**COLD SPRING  
PLANNING & ZONING AGENDA  
September 13, 2023  
6:30 PM**

FILE NUMBER: PZ-23-033  
LOCATION: Multiple Parcels Comprising Approximately Seventy (70) Acres at the South-East corner of Alexandria Pike (US-27) and AA Highway (KY-9) in Cold Spring, KY  
APPLICANT: Midland Atlantic Properties  
REQUEST: (1) Zone Map Amendment from Residential-Rural Estate (R-RE), Residential-Rural Estate\* (R-RE\*), Residential-One C (R-1C) and Residential-Three (R-3) to Mixed-Use Planned Development (MUPD) and Highway Commercial-Two (HC-2); and (2) Approval of Stage I and Stage II plans for the development of a Mixed-Use Commercial Development.

Figure 7: Proposed zone map amendments

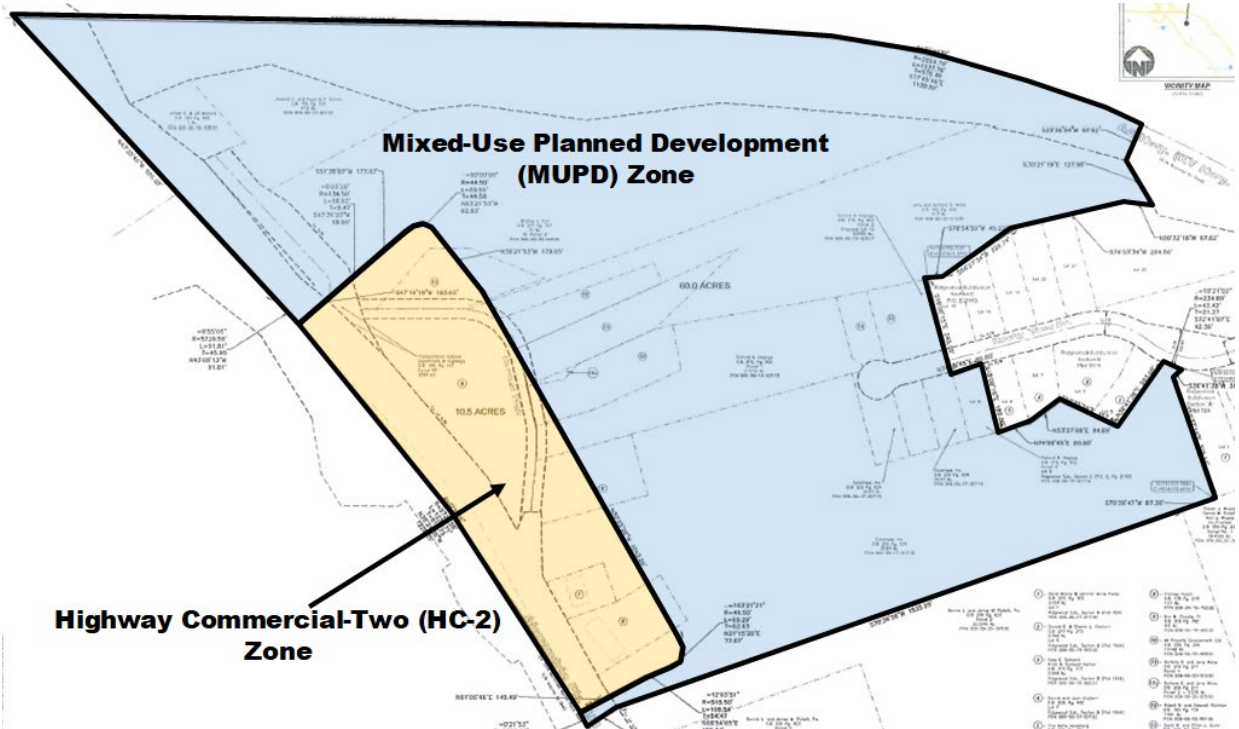
**Staff Comment – Zone Map Amendment**

The proposed zone change is in agreement with the adopted 2018 Comprehensive Plan. The existing zoning classifications at these properties are inappropriate. The proposed zoning classification of Mixed-Use Planned Development (MUPD) is appropriate for the majority of the site. Because of proposed uses on the plan, an area of Highway Commercial-Two (HC-2) is proposed to allow uses in that location not permitted within an MUPD zone.

Staff recommends that the zoning designation be changed from R-RE, R-1C and R-3 to MUPD at the 60.15 acre section designated on the site plan, and from R-RE and R-3 to HC-2 at the 10.39 acre section designated on the site plan.

Sheet: **C3.0**

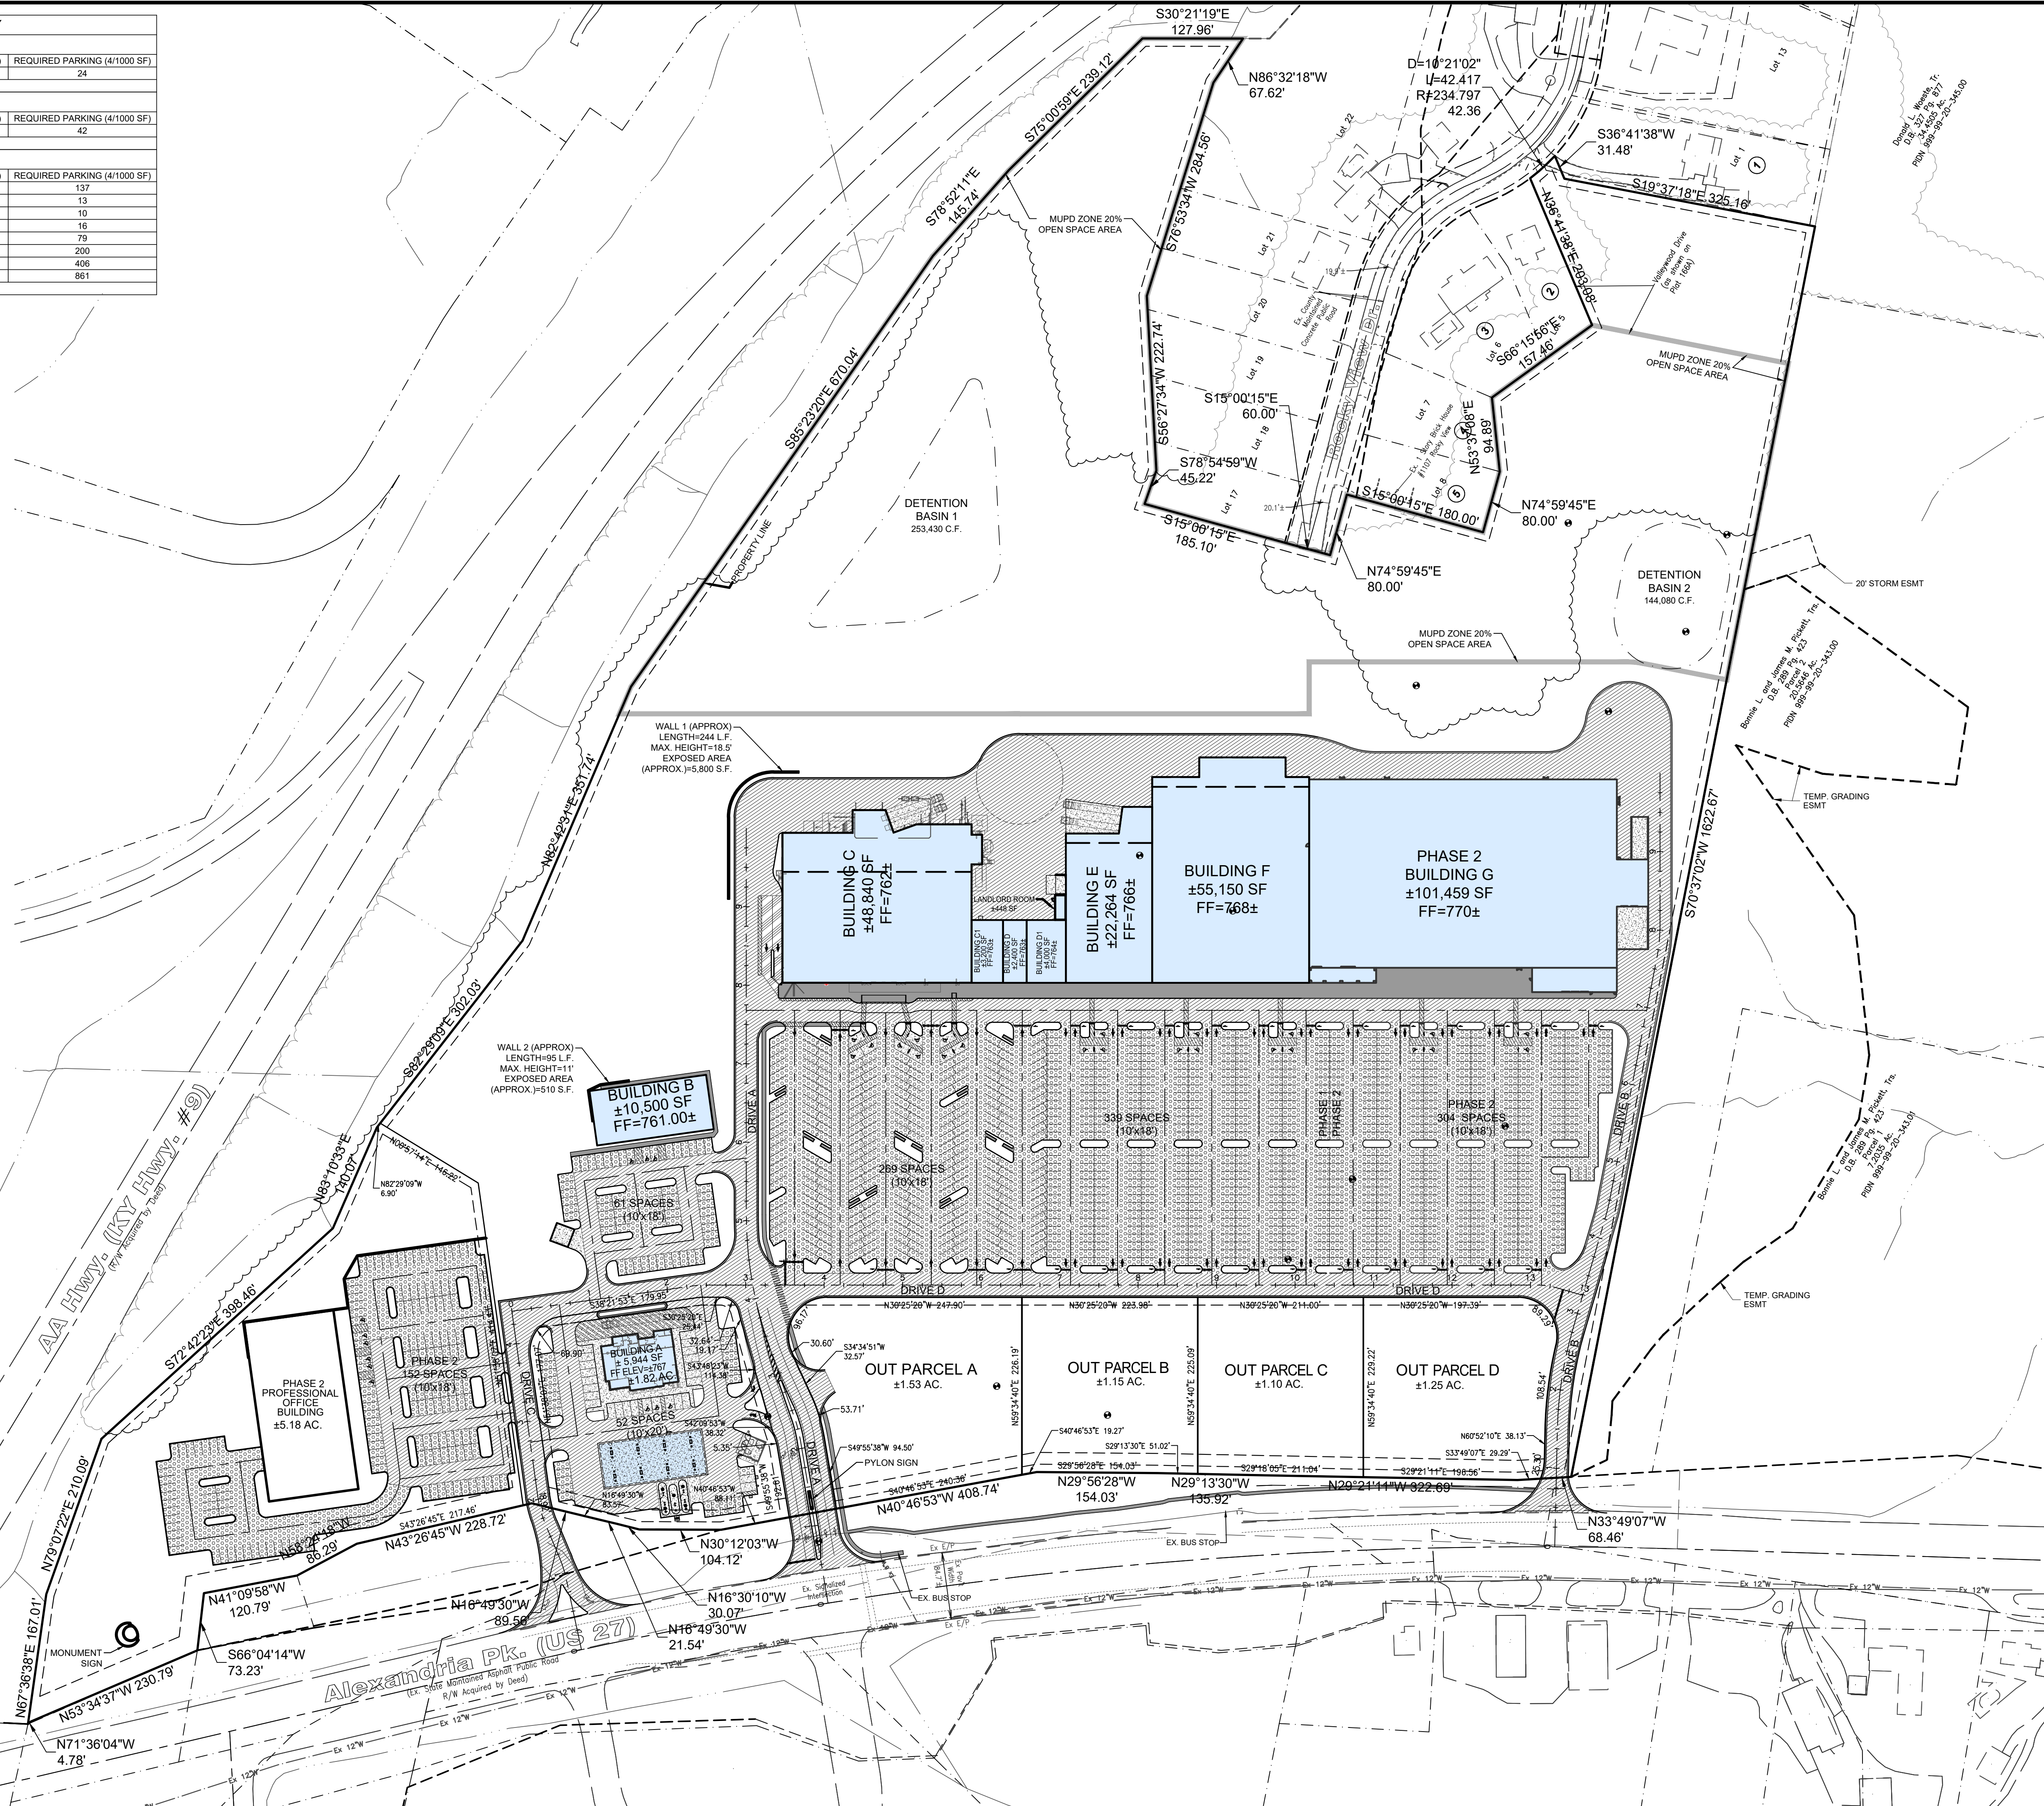
*"Midland will extend the walk further north to the right-in/right-out at the fuel station/convenience store that is not currently shown on the plan. This will connect all 3 access drives and provide walks from the south end of the property to the north for approx. 1,325' or about 2/3 of the total frontage length of 2,000'. The remaining section north of the right-in/right-out drive leads to the bridge/overpass of the AA Highway where pedestrian access is not provided, similar to the development on the north side of AA Highway. Midland will improve the bus stop areas along the provided walks adjacent to US 27."*

The applicant has proposed an updated sidewalk design subsequent to the original application submittal (see applicant comment above). Updated drawings showing the revised sidewalk are not available at the time of this writing.

3. To approve the waiver of sidewalk requirements with the following condition:
  - a. That the proposed sidewalk as shown on the plans be extended to meet the Phase 2 Professional Office Building either by appropriate striping within the complex, a paved extension, or a combination of both.
4. To approve the Site Development Plan with the following conditions:
  - a. That the subject area currently in Unincorporated Campbell County be annexed in to the City of Cold Spring,
  - b. That an engineering review be completed by a City-authorized engineer.
  - c. That a traffic study be completed.
